Attachment B: Further Information – Road Exchange Process

GLENPANEL SHA INFRASTRUCTURE
ASSESSMENT PEER REVIEW
PREPARED FOR
QUEENSTOWN LAKES DISTRICT COUNCIL
114562.02
28 JULY 2016

Glenpanel SHA Infrastructure Assessment Peer Review

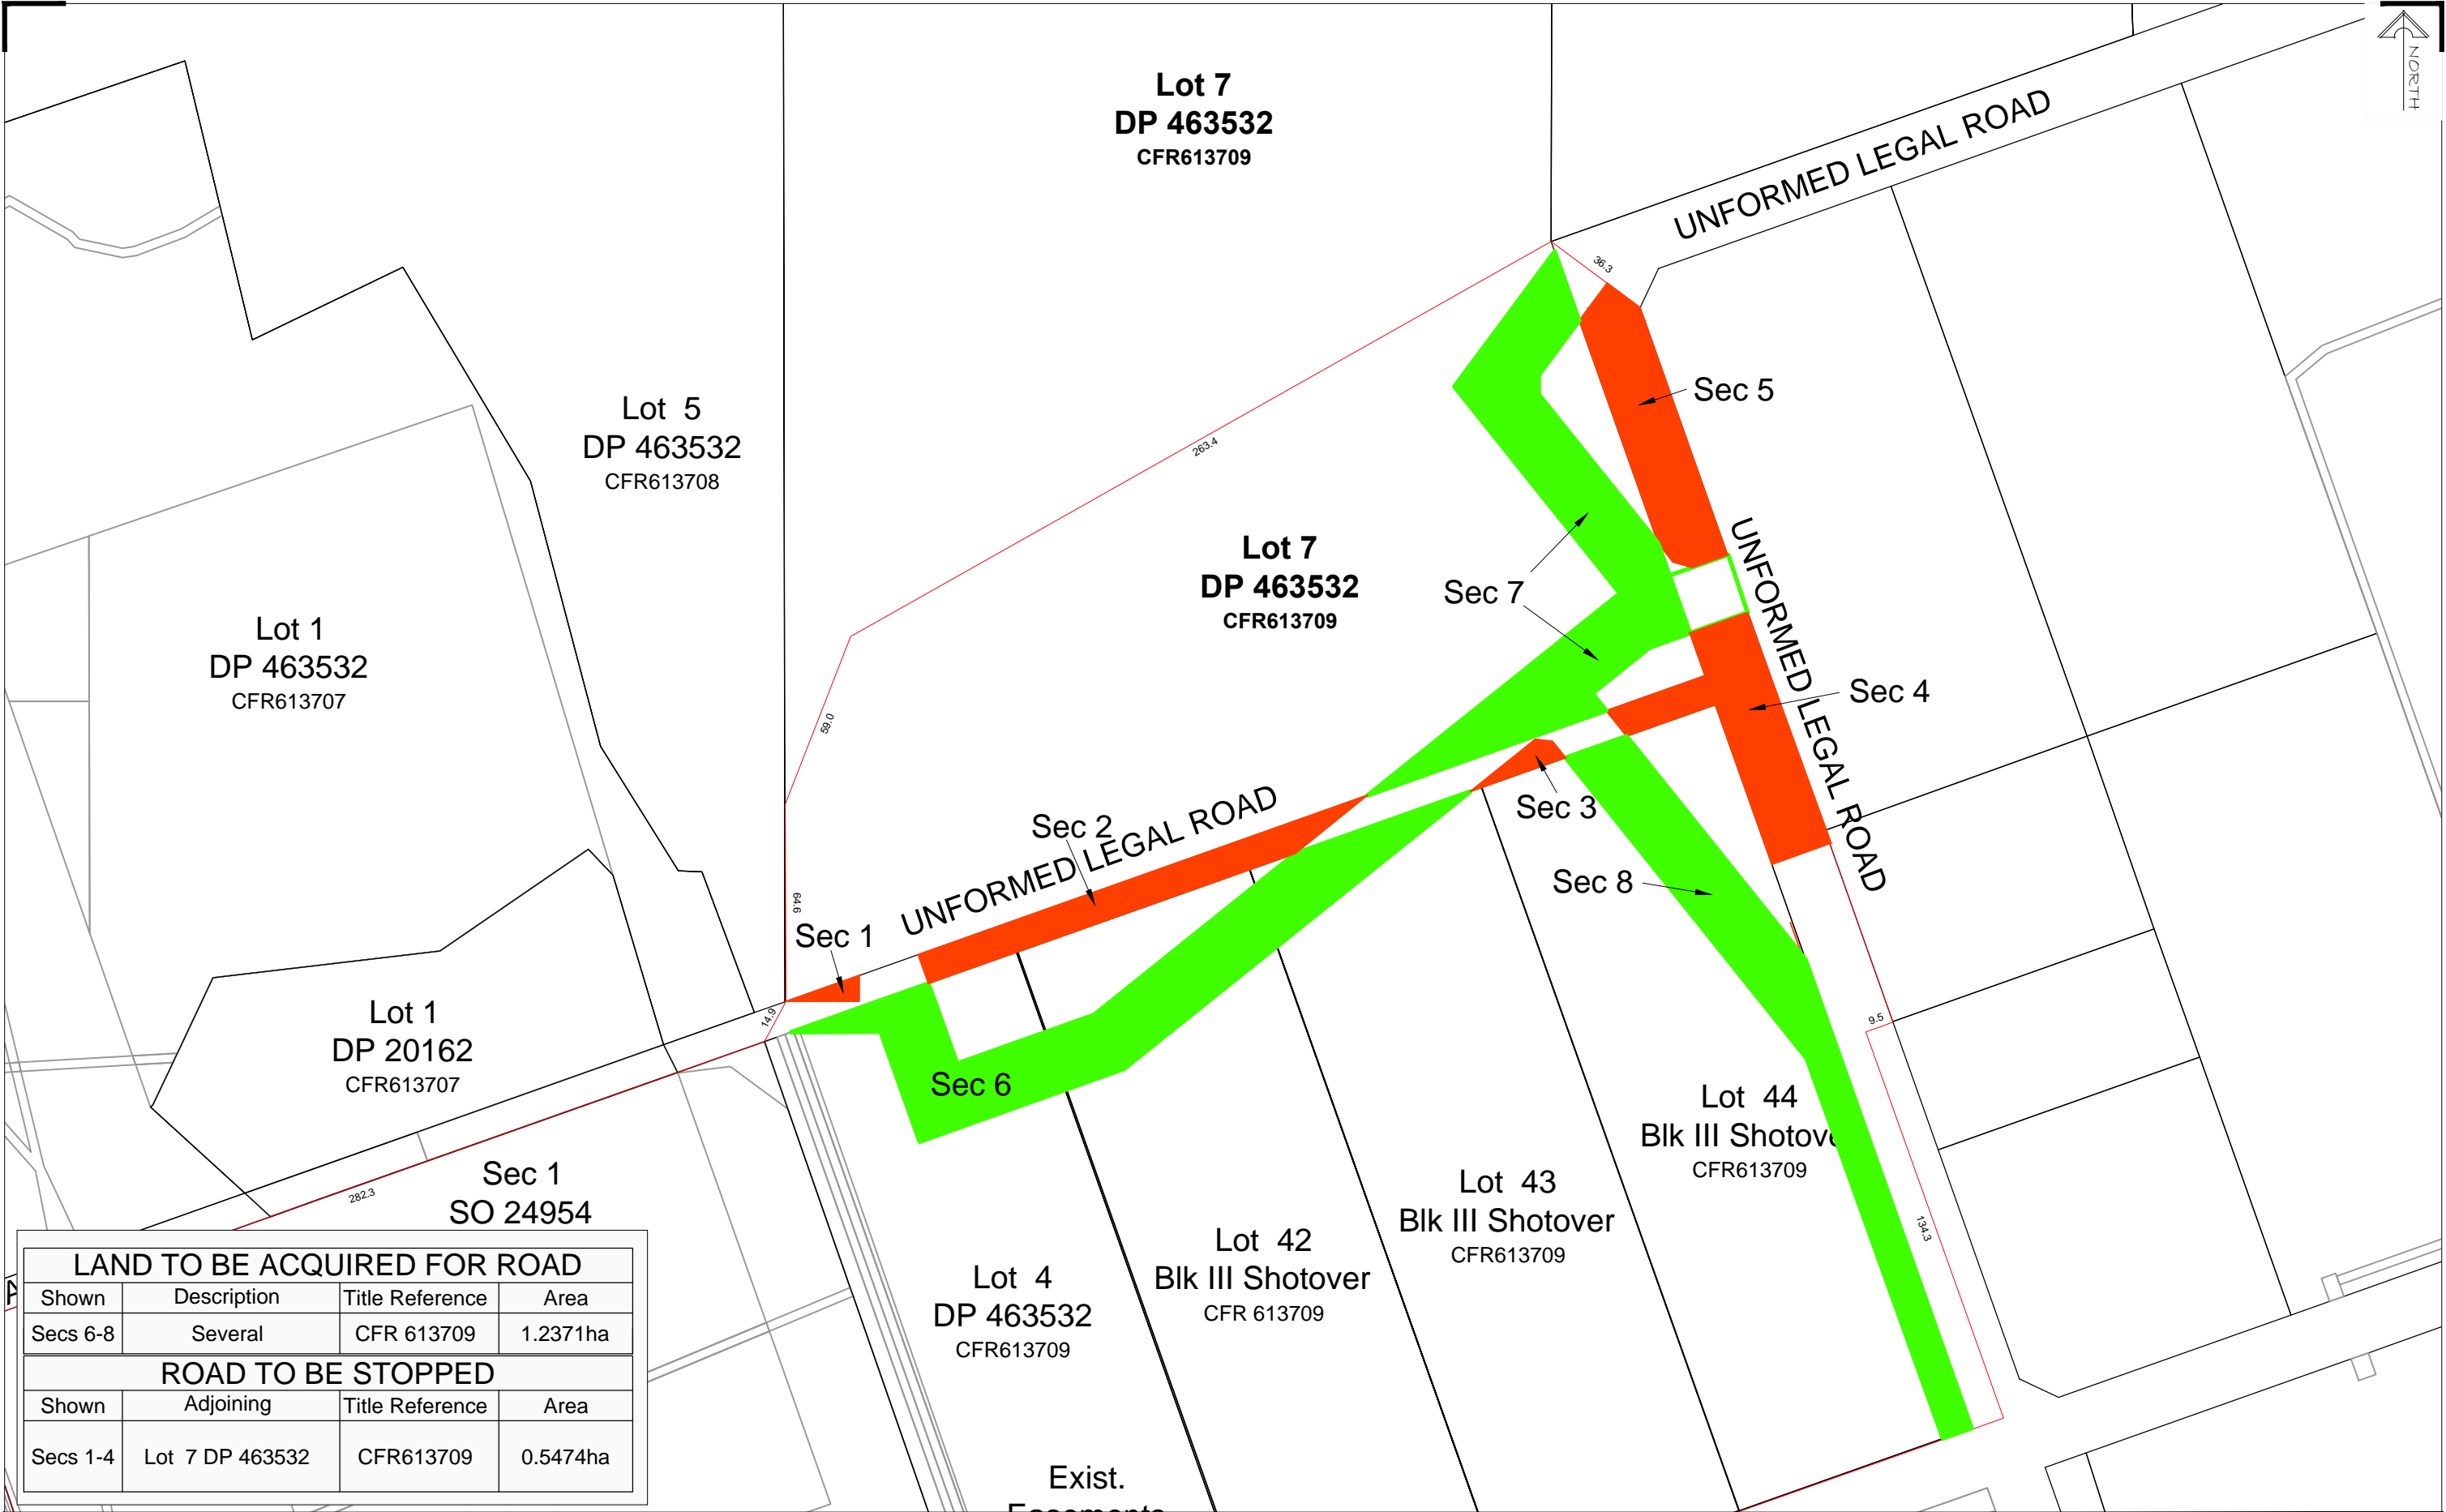
We have also completed a legalisation concept showing the sections of road to be exchanged.

In simple terms the green sections are 'swapped' for the red sections. The exchange would be 'like for like' and in this instance we would exchange farm land for farm land. This process would occur for nil consideration between the parties.

The connections to the existing legal roads are left intact so no changes in the connectivity of the existing legal road. i.e. the roads are not severed in any way.
